CRMC DECISION WORKSHEET

2022-12-075

BIOLOGIST ADDENDUM

STATE OF RHODE ISLAND
COASTAL RESOURCES MANAGEMENT COUNCIL
STAFF REPORT TO THE COUNCIL

Figure 4: 2022-12-075 STORMTOOLS

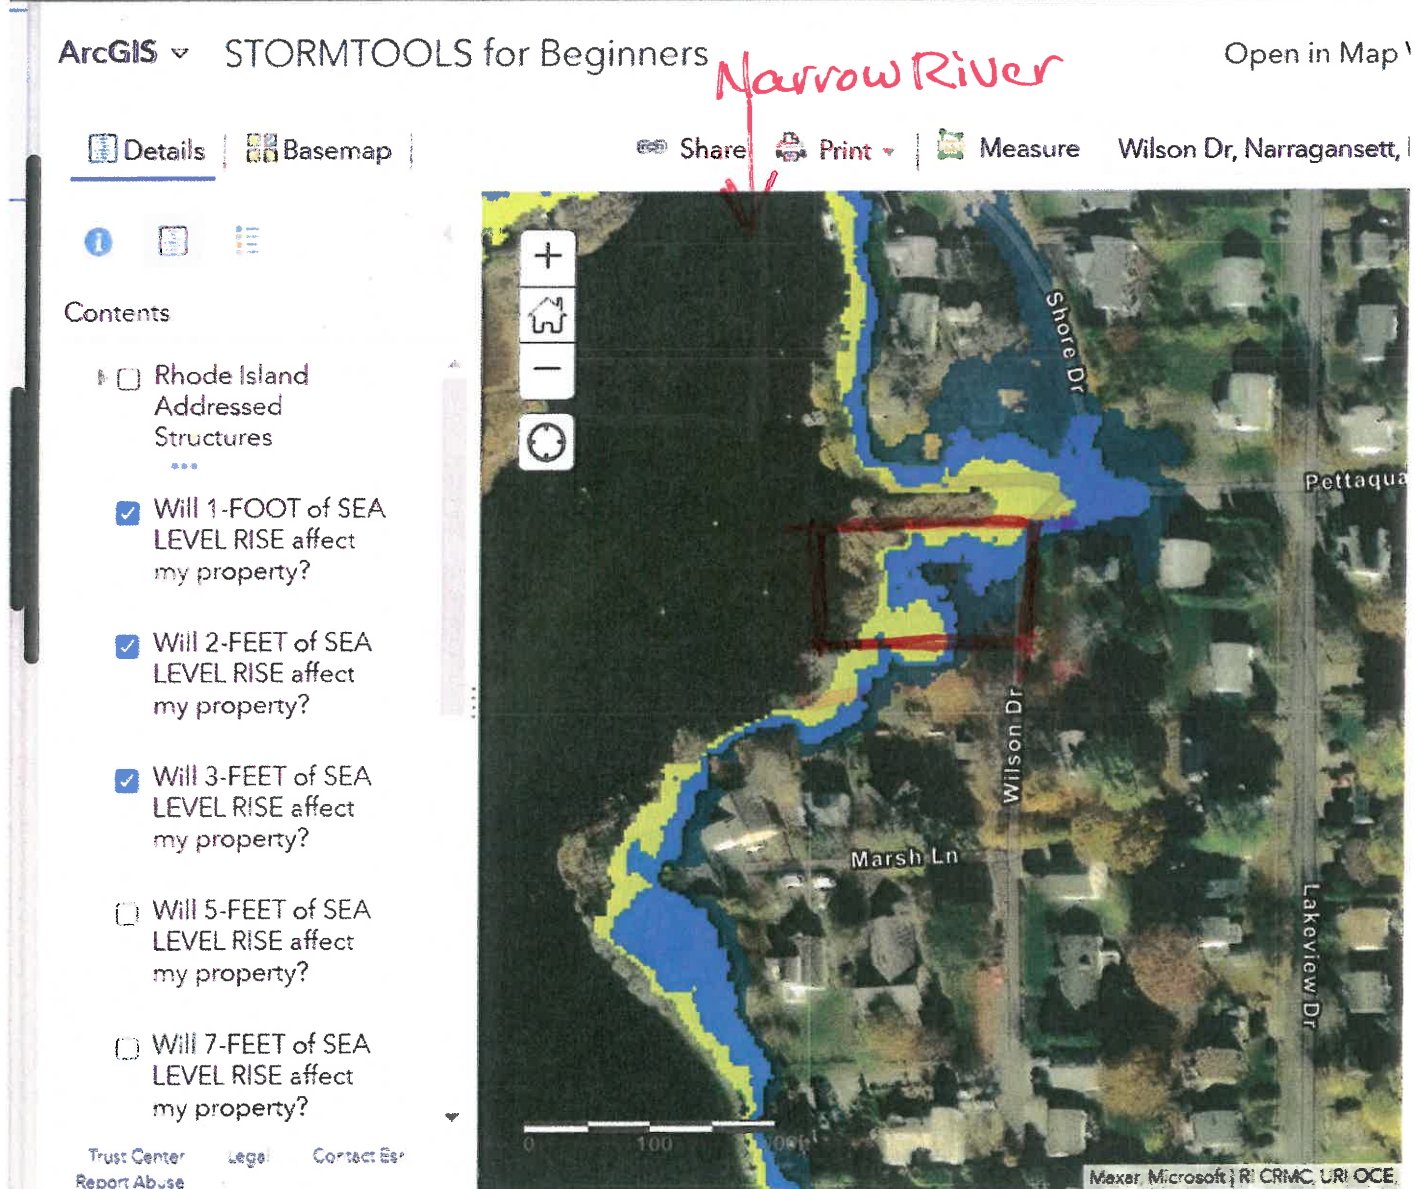
Another component of the CHA, the Coastal Environmental Resource Index (CERI) shows potential damage estimates for a site due to coastal hazards; Severe Damage likelihood, including Inundation was found for this site. It is important to note that SLR estimates are for twice-daily tidal flooding affecting access/egress and/or use of the site. A storm flooding event is additive impacts and *Figure 4* shows the extent of flooding likely with only 1'SLR + a 10-year nuisance storm event, not including rainfall.
